DEPARTMENT OF CITY PLANNING

APPEAL RECOMMENDATION REPORT

Case No.: DIR-2017-5367-DB-CDO-1A
CEQA No.: ENV-2017-5368-CE
Related Cases: None
Council No.: 13 – O’Farrell
Plan Area: Silver Lake – Echo Park – Elysian Valley
Specific Plan: None
Certified NC: Echo Park
GPLU: Low Medium II Residential
Zone: RD2-1VL-CDO
Applicant: Daniel Pourbaba
Representative: Todd Elliott
Truman & Elliott LLP
Appellant(s): Cody Briggs, Montrose
Condos Homeowner’s
Association

PROJECT LOCATION: 923-929 Glendale Boulevard, 1810 West Montrose Street

Revised Landscape Plan

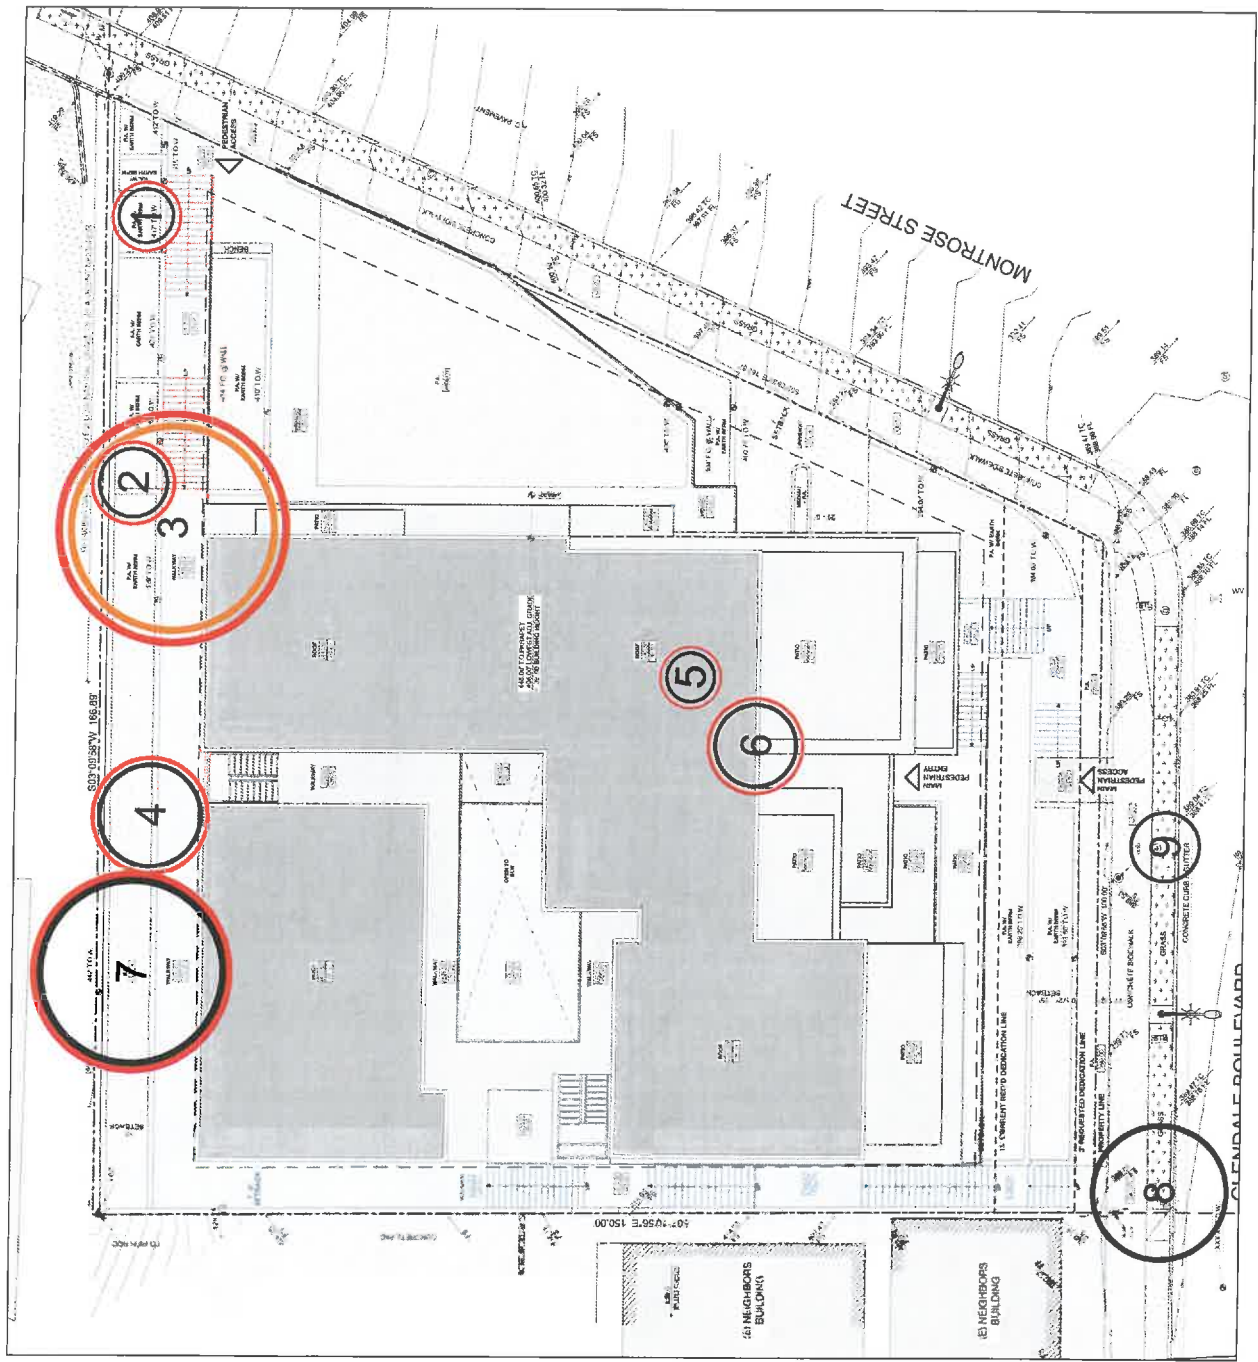
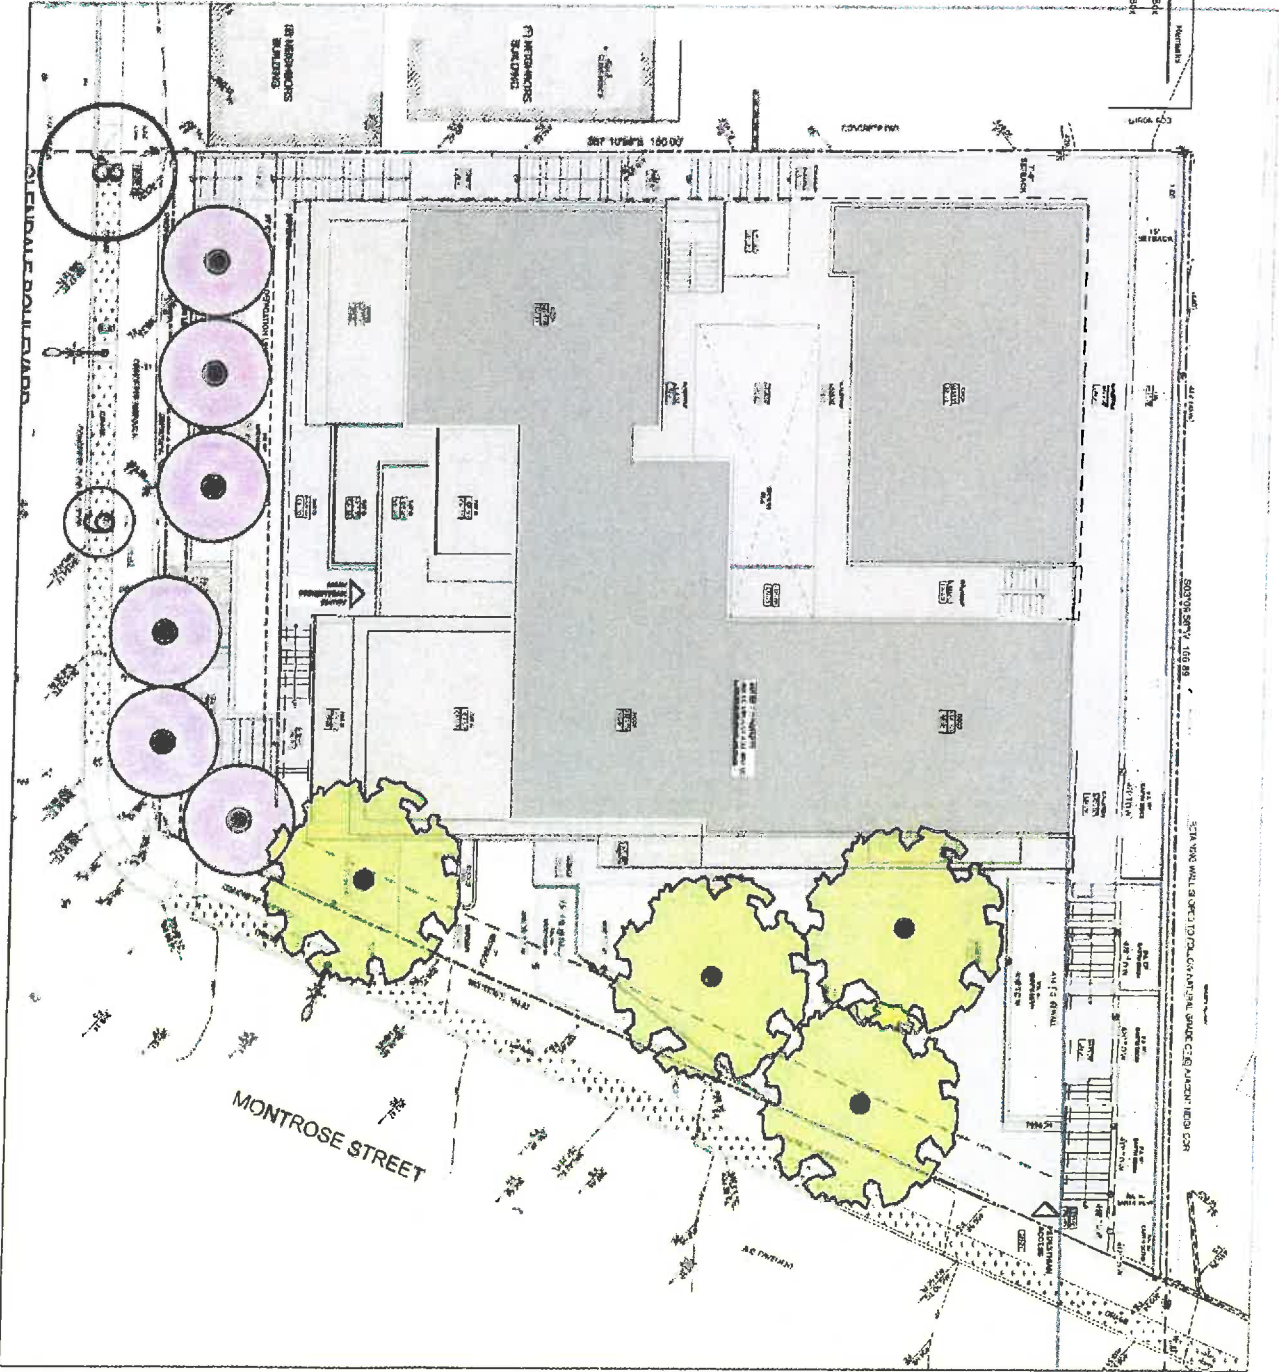
The initial filing did not include information about the existing trees. After an appeal was filed, the applicant provided a tree report, from Mr. Paul Lewis, Landscape Architect, who found one Juglans Californica (Black Walnut) tree is in fact on the site, and three non-protected trees. All trees are proposed to be removed. The removal of the protected tree will require a permit and review by the Urban Forestry Division of the Bureau of Street Services. The removal of the protected tree will require replacement at a four to one ratio. In addition, the Project will be required to provide additional trees per LAMC Section 12.21G at a ratio of one tree for every four dwelling units proposed.

Therefore, a technical modification is included as part of this appeal report and the amended landscape plans were submitted to demonstrate compliance with the replacement requirements for protected trees and LAMC Section 12.21G.
